CCK-2583.2-1-24 Nutter Field House Gymnastics ADDENDUM # 1 9/18/2023

Nutter Field House Gymnastics JRA Project No. 202305 UK Project CCK-2583.2-1-24 University of Kentucky Lexington, Kentucky

The Addendum will form a part of the Contract Documents and modifies the original Bidding Documents dated September 2023.

A-001

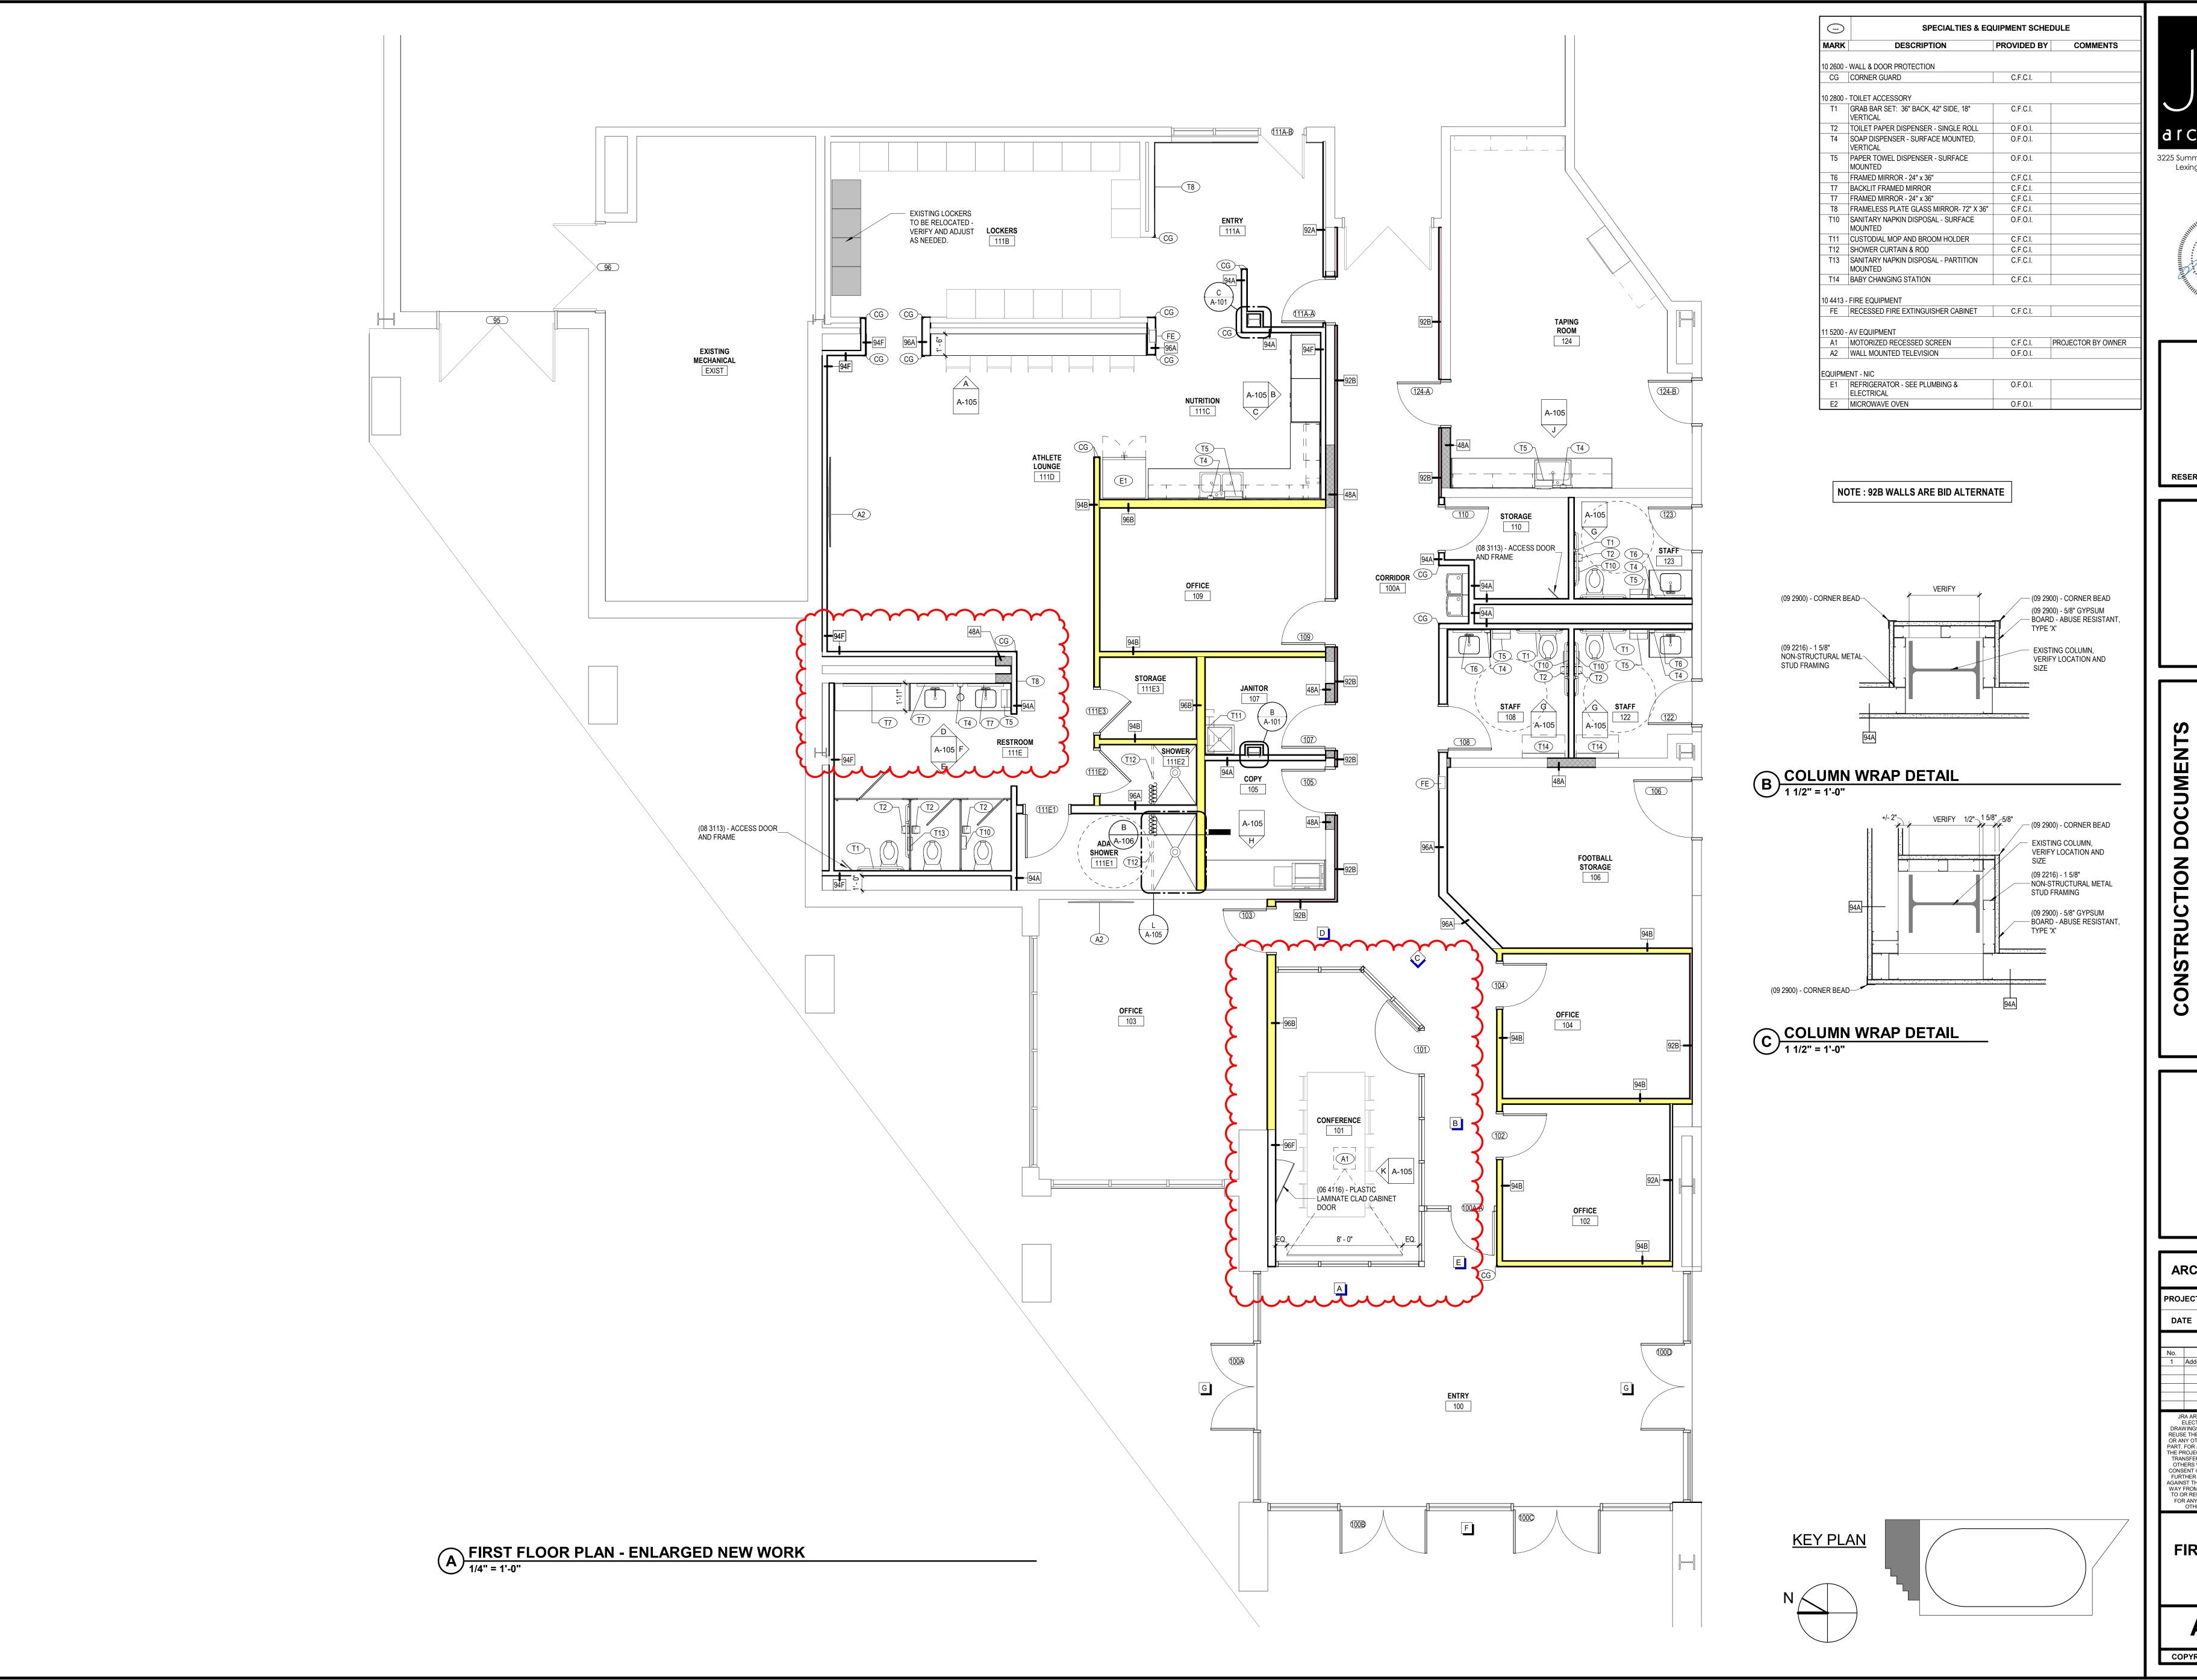
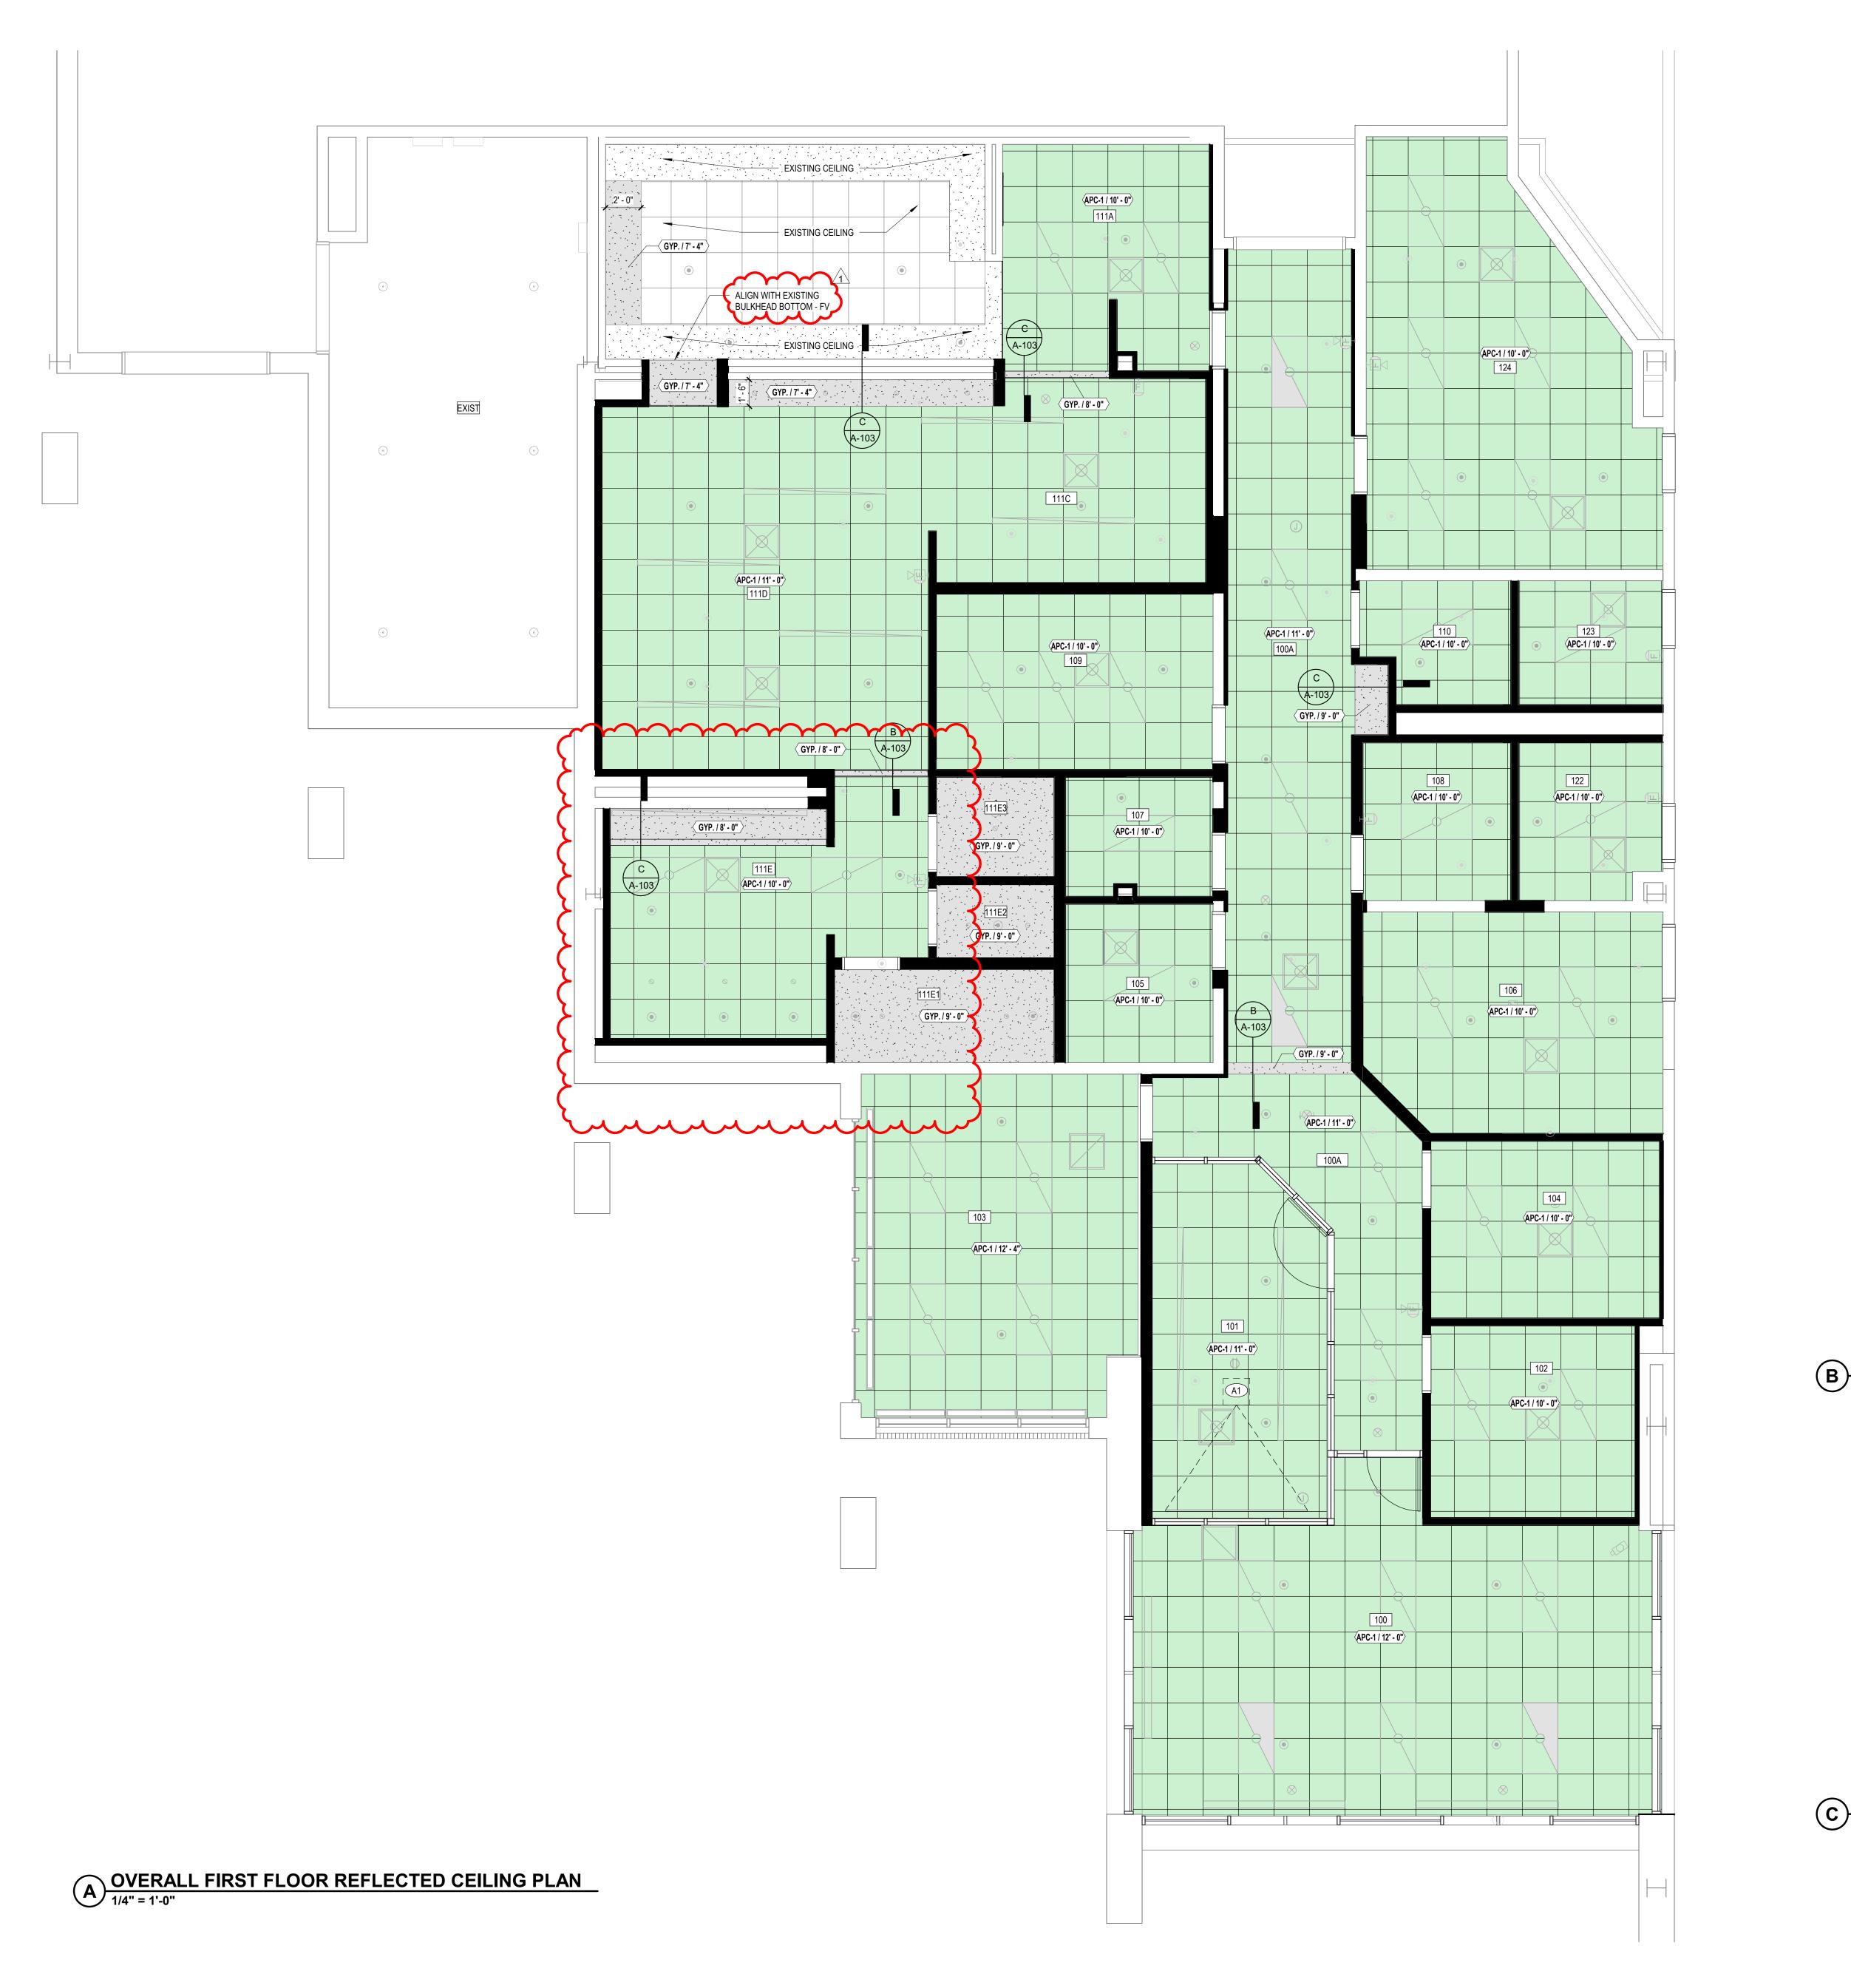
Added clarification for lockers on demo sheet A-001

A-103

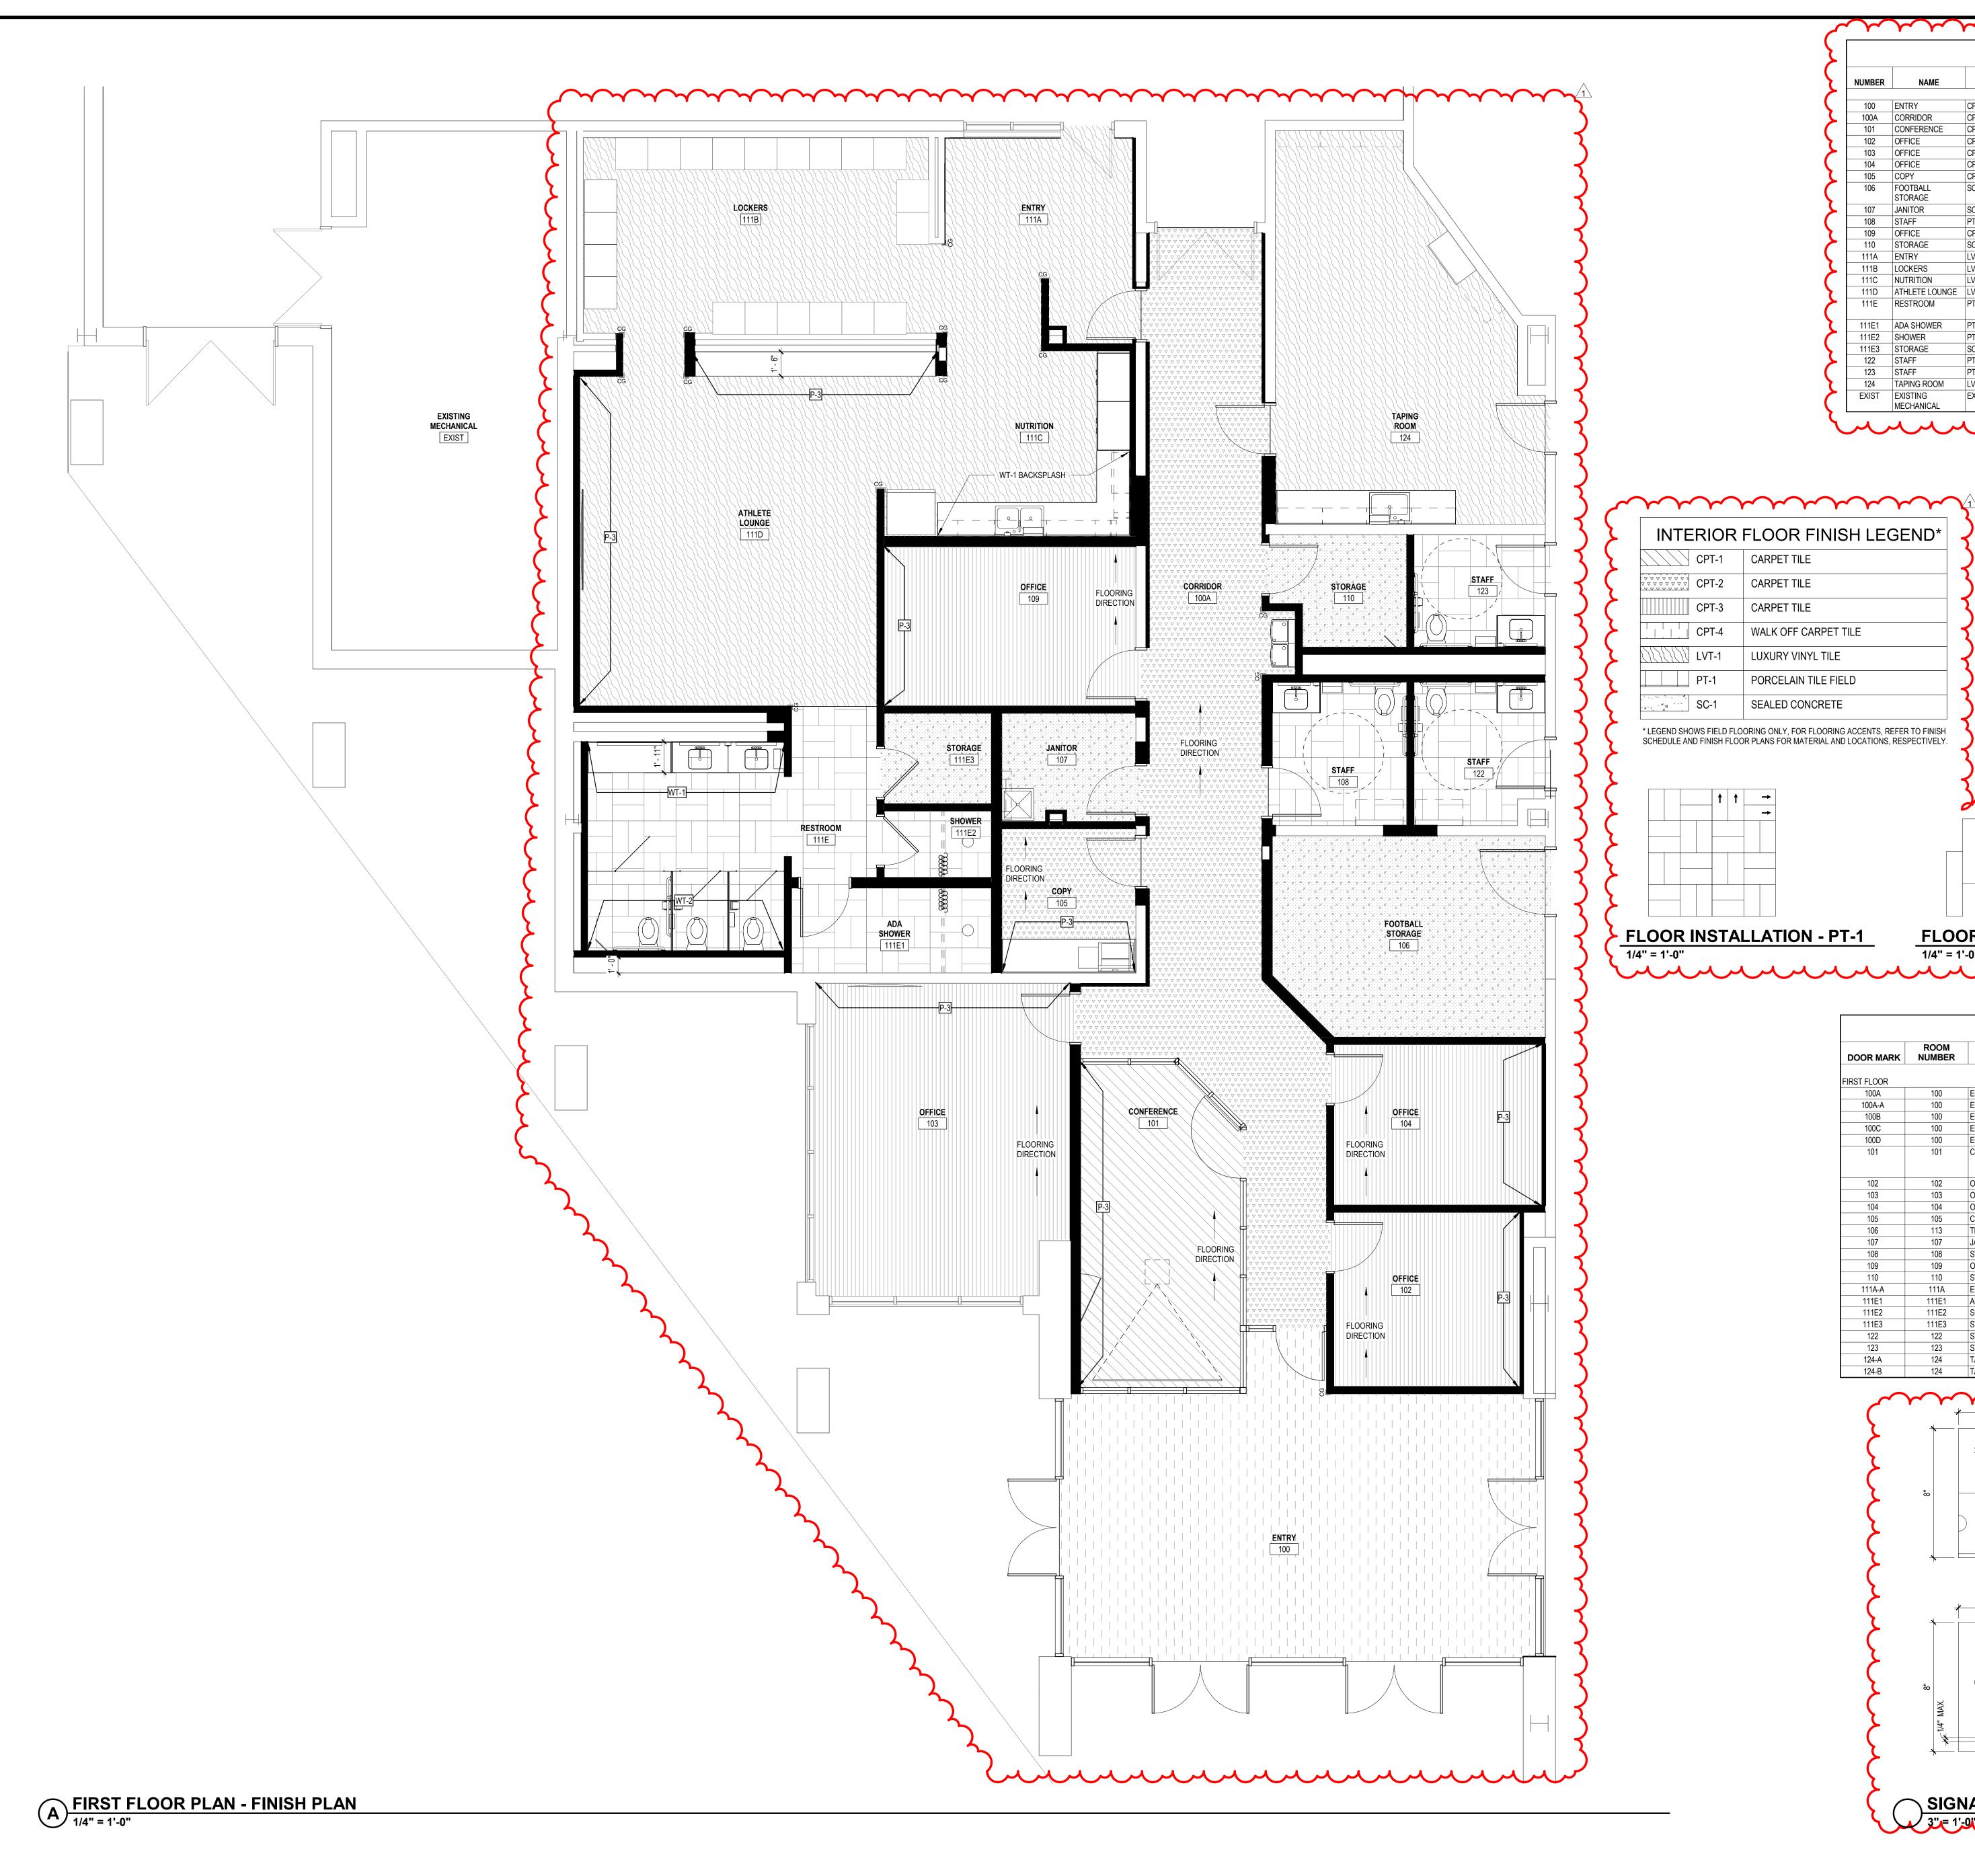
Removed APC-2 from scope, clarified existing ceiling locations. See attached sheet A-103.
